Applicant: Scott Douglas; Cross View Lutheran Church  
Consultant: Vicki Van Dell; Loucks  
Project: Building Addition and Parking Lot Improvements for Cross View Lutheran Church  
Location: 6646 McCauley Trail: Edina  
Rule(s): 4,5,11 and 12  
Reviewer: BCO

**Permit #:** 2018-102  
**Project Name:** Cross View Lutheran Church Building Addition and Parking Lot Improvements – 6646  
McCauley Trail: Edina  
**Approval Date:** May 15, 2019

C3.2

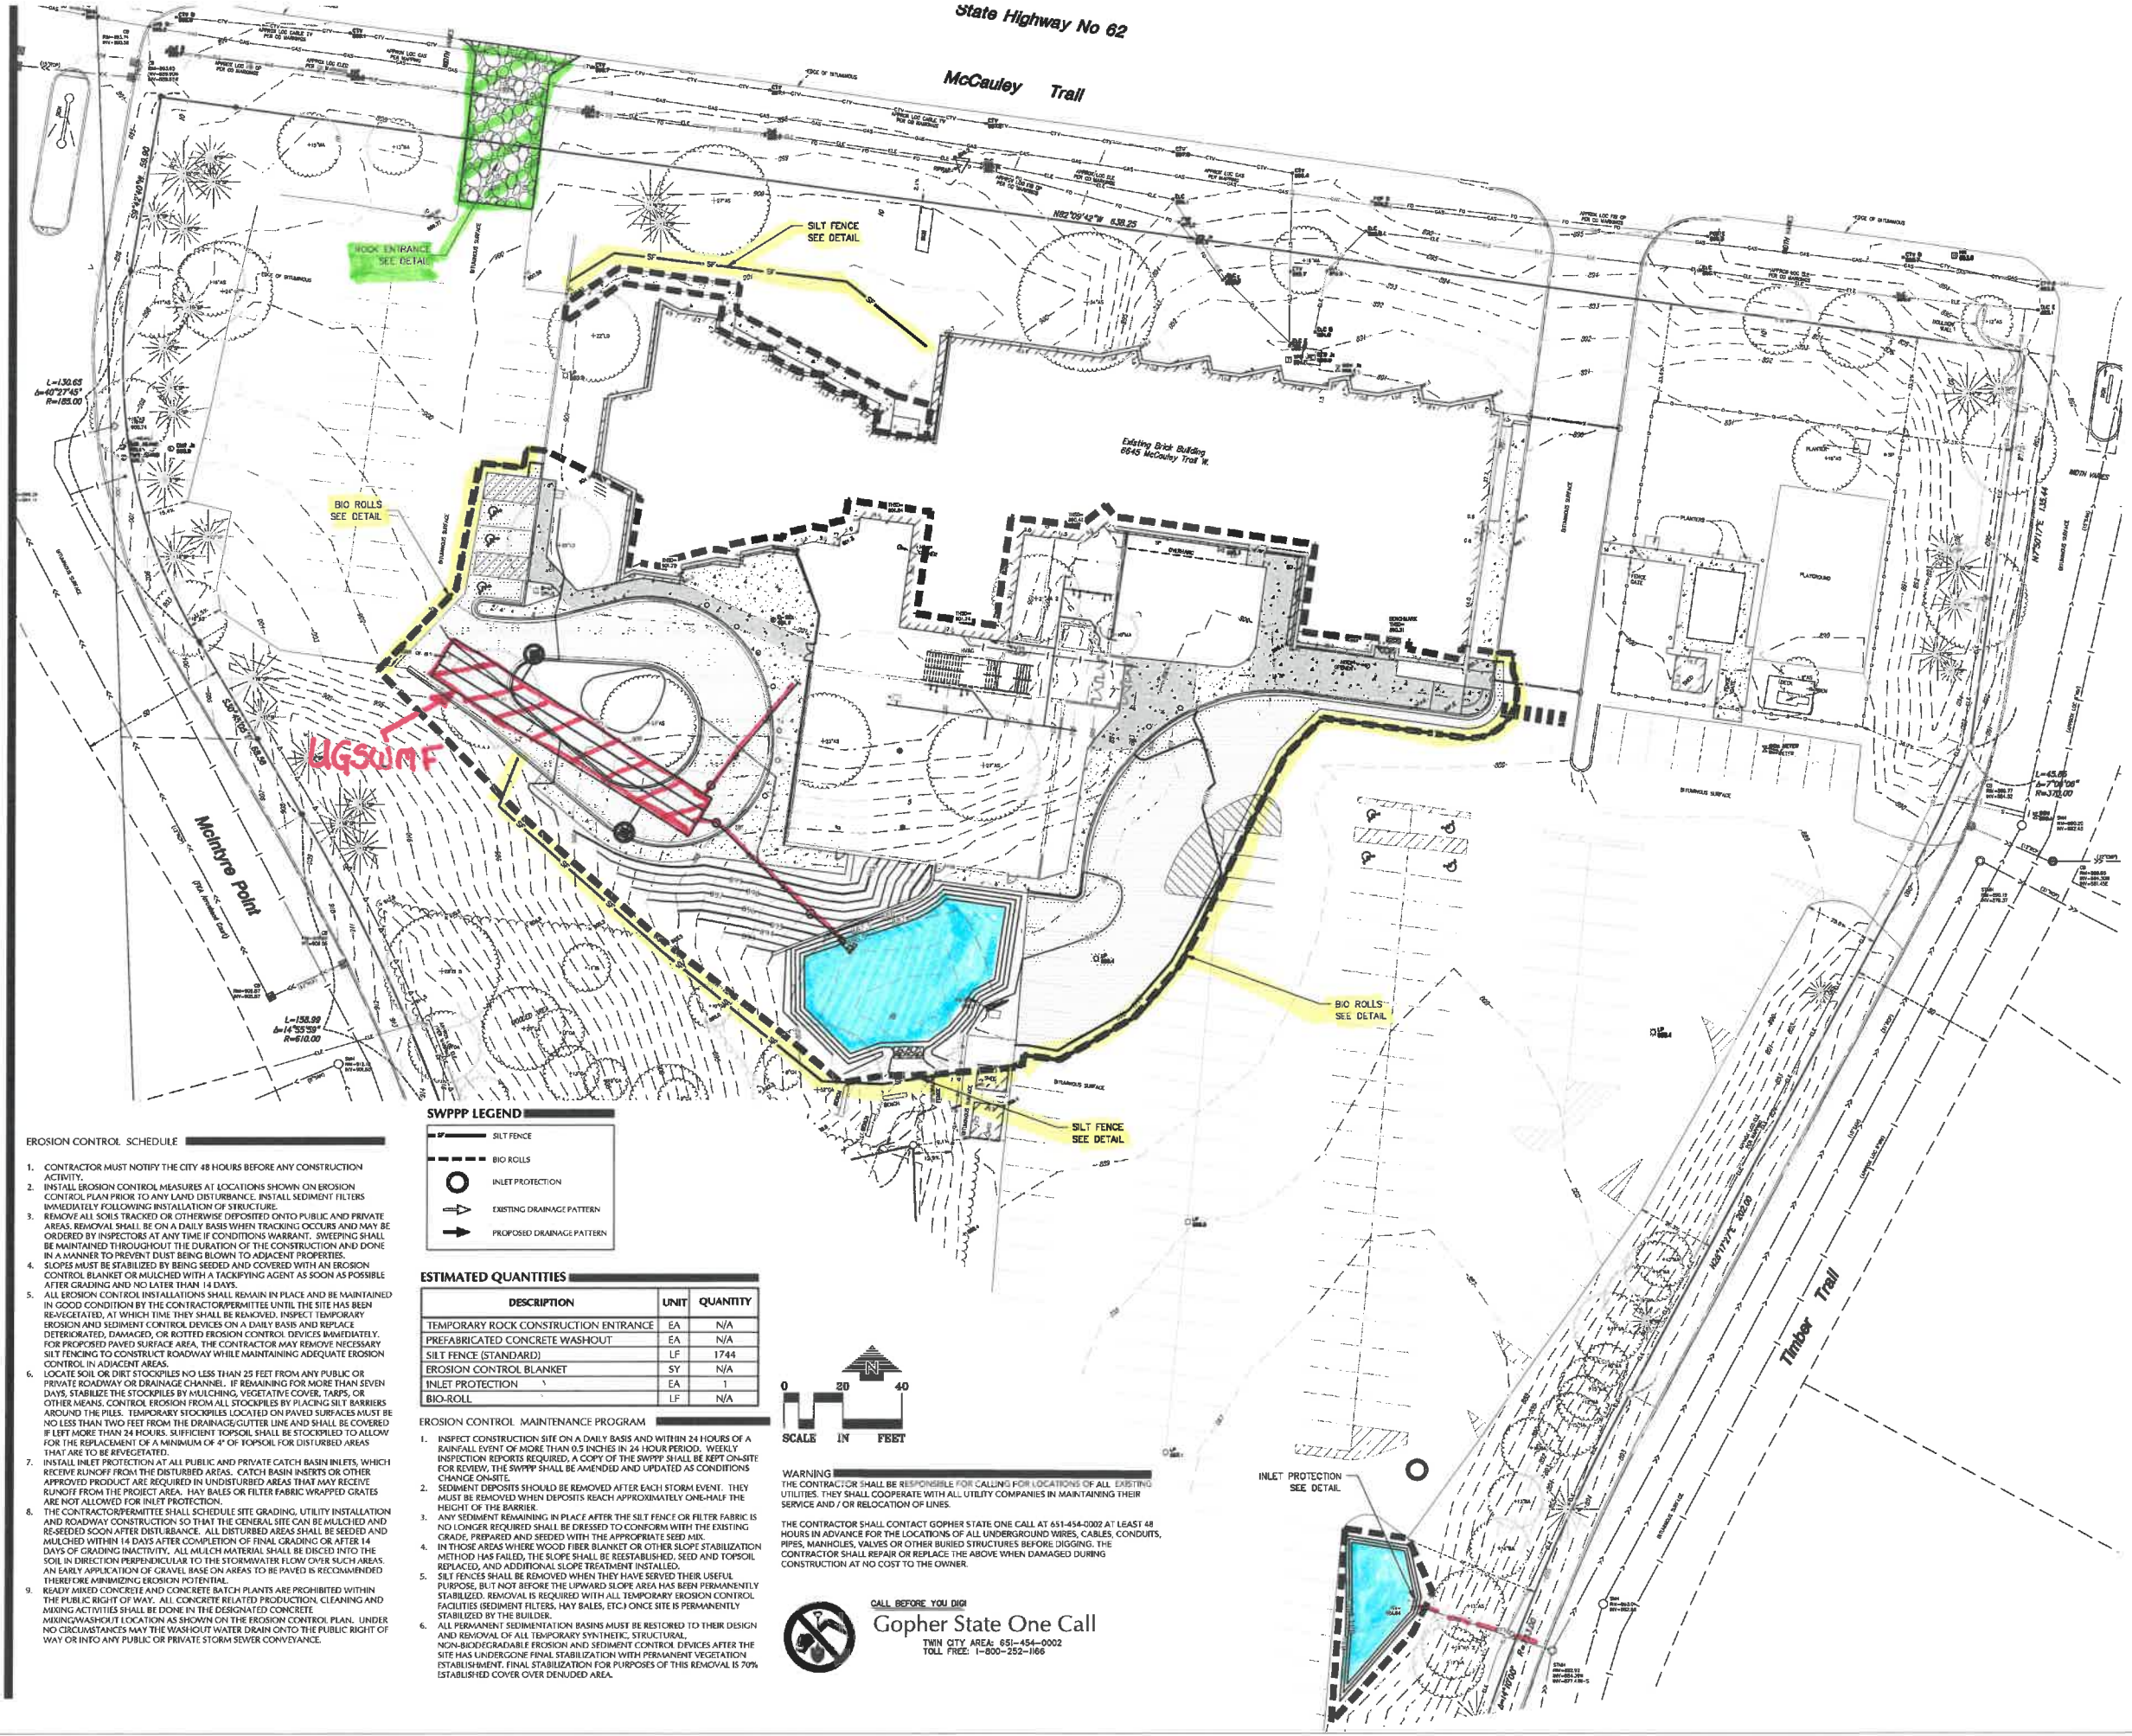
Silt fence, inlet protection and a rock construction entrance are to be installed to provide erosion control.

The submitted erosion and sediment control plan includes silt fence at the limits of construction, inlet construction and a rock construction entrance at the entryway onto the site. The project contact is Vicki Van Dell, Loucks.
